UNITED STATES PATENT AND TRADEMARK OFFICE

10/664,666

Office Action Summary	Application No. 10/664,666	Applicant(s) HACKLER ET AL.	
	Examiner Eric W Thomas	Art Unit 2831

- 1) ☒ Responsive to communication(s) filed on 19 October 2004.
- 2a) ☒ This action is **FINAL**. 2b) ☐ This action is non-final.
- 3) ☐ Since this application is in condition for allowance except for formal matters, prosecution as to the merits is closed in accordance with the practice under *Ex parte Quayle*, 1935 C.D. 11, 453 O.G. 213.

Fig. 4F

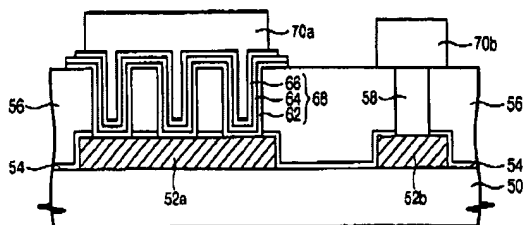
Jin et al. disclose in fig. 4f, a substrate (50), a conductive material (52a) formed above the substrate; an insulating material (54, 56) formed on the conductive material wherein the insulating material and the conductive material serve as a form for defining a plurality of capacitor trenches above the conductive layer, the insulating material defines the trench sidewalls and the conductive material defines the trench bases, a bottom electrode (62) formed onto the capacitor trenches so as to form a layer within the capacitor trenches in contact with the conductive material, wherein the bottom electrode extends up the sides of the capacitor trenches to form bottom electrode sidewalls; a capacitor dielectric (64) at least partially positioned on the bottom electrode; and a top electrode (66) at least partially positioned on the capacitor dielectric.

Regarding claim 11, Jin et al. disclose the bottom electrode further comprises a bottom electrode top wall (see fig. 4F).

Regarding claim 12, Jin et al. disclose the bottom electrode further comprises a bottom electrode base (see fig. 4F).

FIG.19

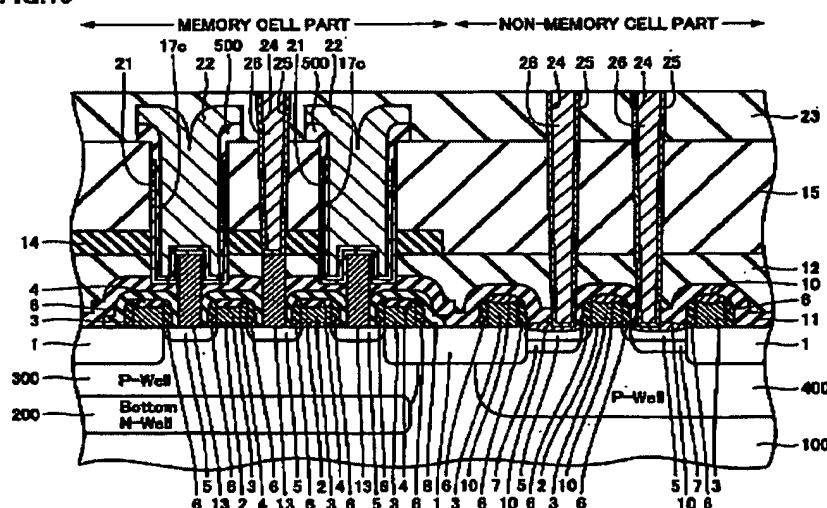
Kubo discloses in fig. 19, a capacitor structure comprising: a substrate (100), an insulating material (12, 14, 15) formed on the substrate, wherein the insulating material serves as a form for defining a capacitor trench; a bottom electrode (21), wherein the bottom electrode comprises a bottom electrode layer in the capacitor trench and a bottom electrode plug (13) disposed in the capacitor trench, wherein the bottom electrode layer extends up the sides of the capacitor trench to form bottom electrode sidewalls; a capacitor dielectric (500) at least partially position on the bottom electrode and at least partially formed on the bottom electrode plug; a top electrode (22) at least partially position on the capacitor dielectric and at least partially formed around the bottom electrode plug.

Regarding claim 35, Kubo discloses the bottom electrode and the capacitor dielectric are formed in the shape of a box (abstract and fig. 19).

Regarding claim 36, Kubo discloses the top electrode is ^{at} least partially disposed in the capacitor trench such that the top electrode interdigitates the bottom electrode (see fig 19).

Regarding claim 37, Kubo discloses the bottom electrode further comprises a bottom electrode top wall (see fig. 19).

Regarding claim 38, Kubo discloses the bottom electrode further comprises a bottom electrode base (see fig. 19).
